CIRCULATED AT MEETING
AGENDA ITEM 4C) HILARY HOUSE, ST SAVIOUR'S
PLACE

City of York Council Planning Sub-Committee
Hilary House, now Biba House, YO1 7PJ
9th June 2016

PLAN "A"

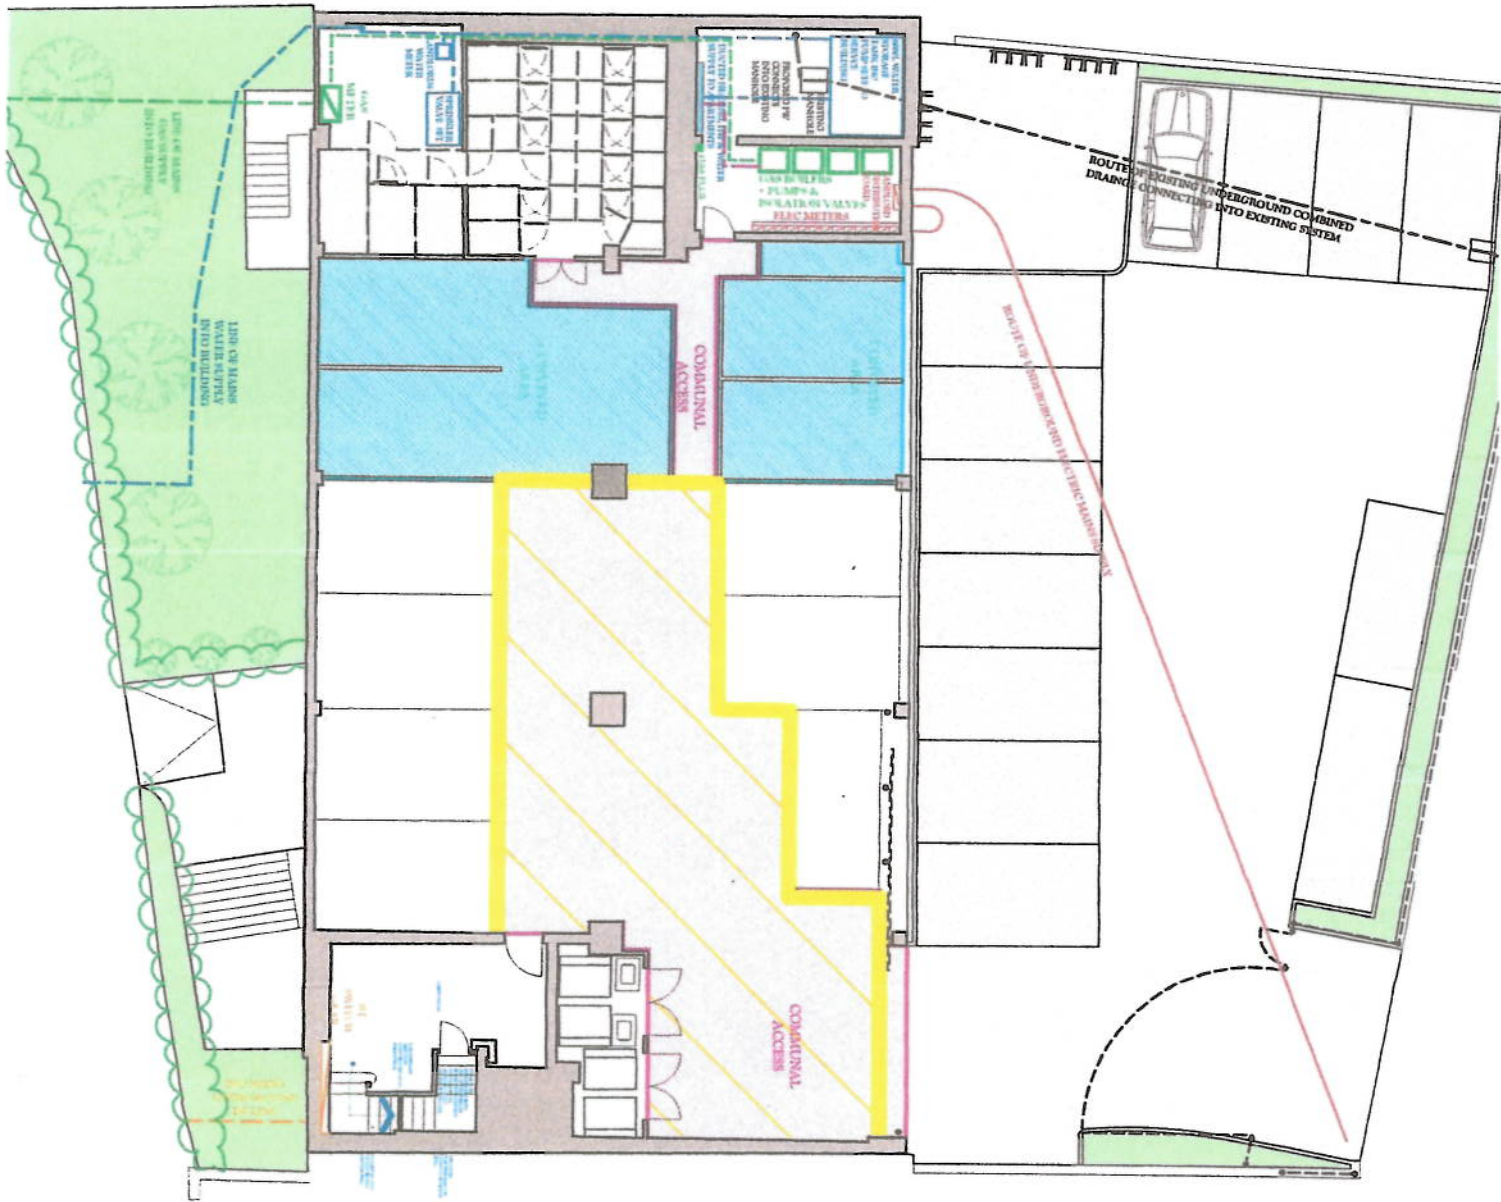
The attached Plan A shows 13 spaces outside the building and 11 in the basement. We have no issue with the outside parking. However, inside the building there is not room for 11 usable spaces, only 9 - the lines on the ground are entirely misleading.

There are 4 flats unsold in the development and at least one which is sold but not let. Therefore none of the parking allocated to these flats is in use, and most of the basement parking is unoccupied. Once these flats are sold, however, and the car park is full, it will be physically impossible to access the four far end spaces and extremely difficult to park in the remaining spaces.

PLAN "B"

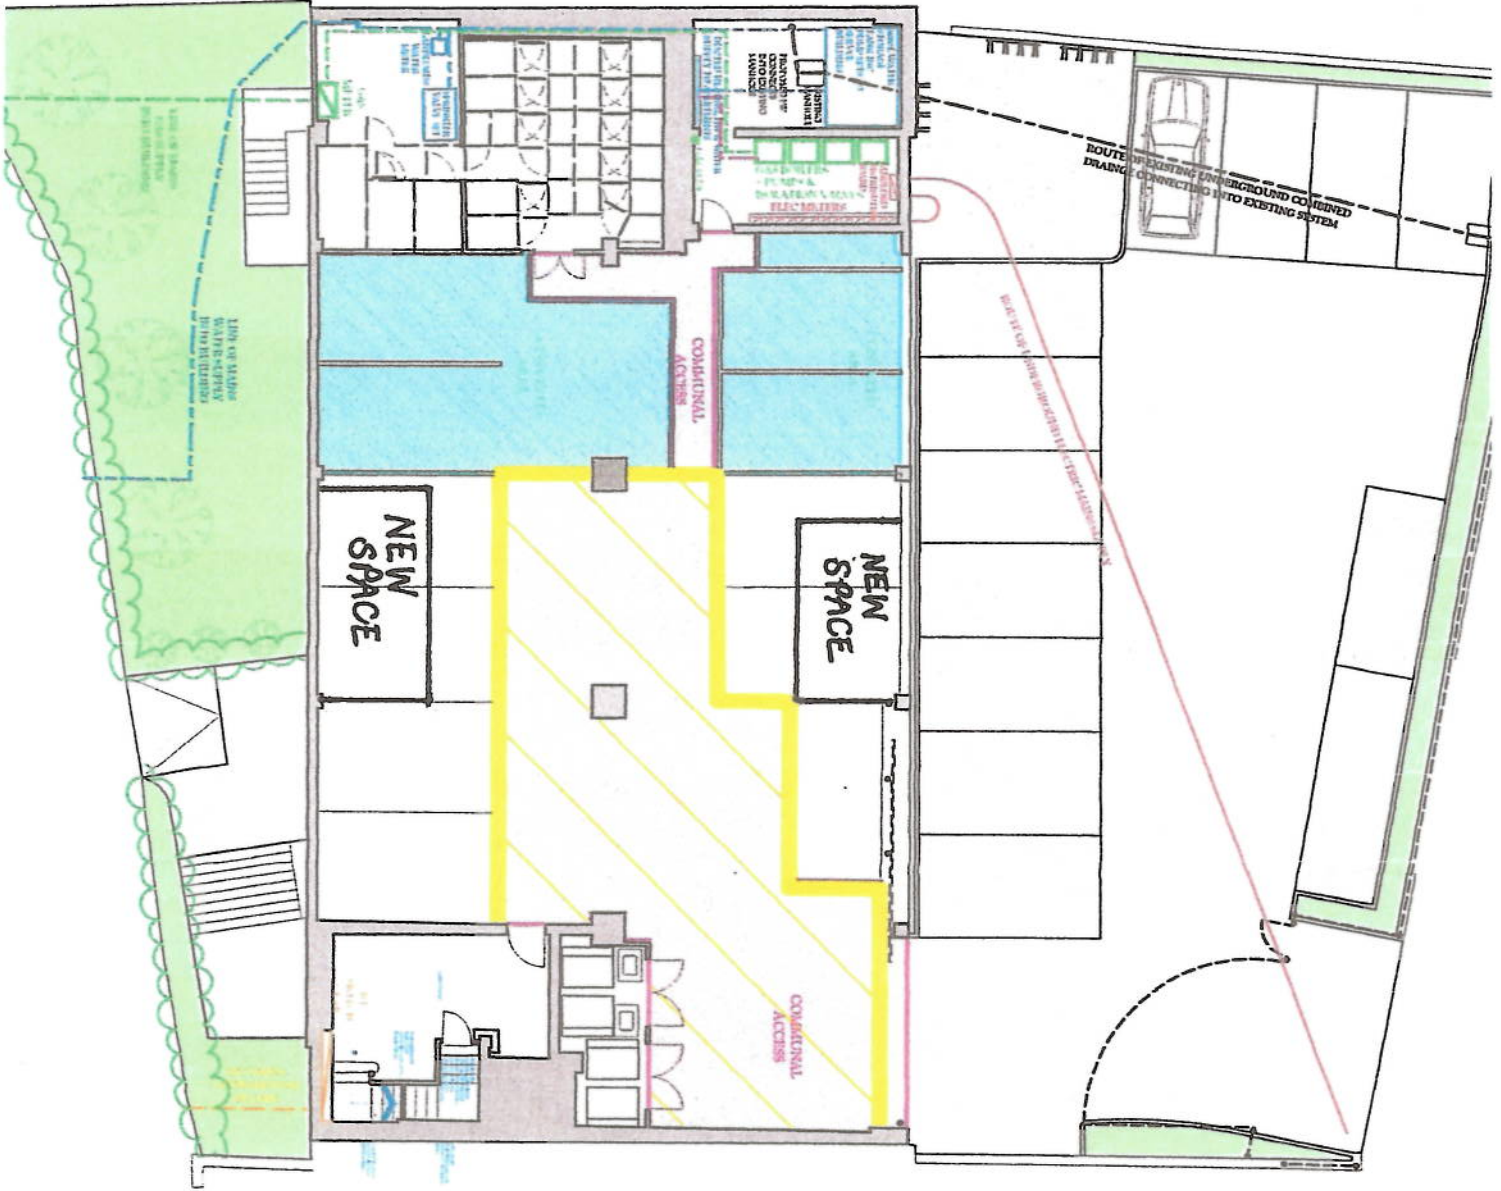
Plan B shows an alternative layout which would create real spaces as opposed to fictitious ones. However, this does mean reducing the number of indoor spaces to 9 and would leave no available space for allocation to the proposed penthouse. If the Applicant has indicated that there is parking available, this is not true.
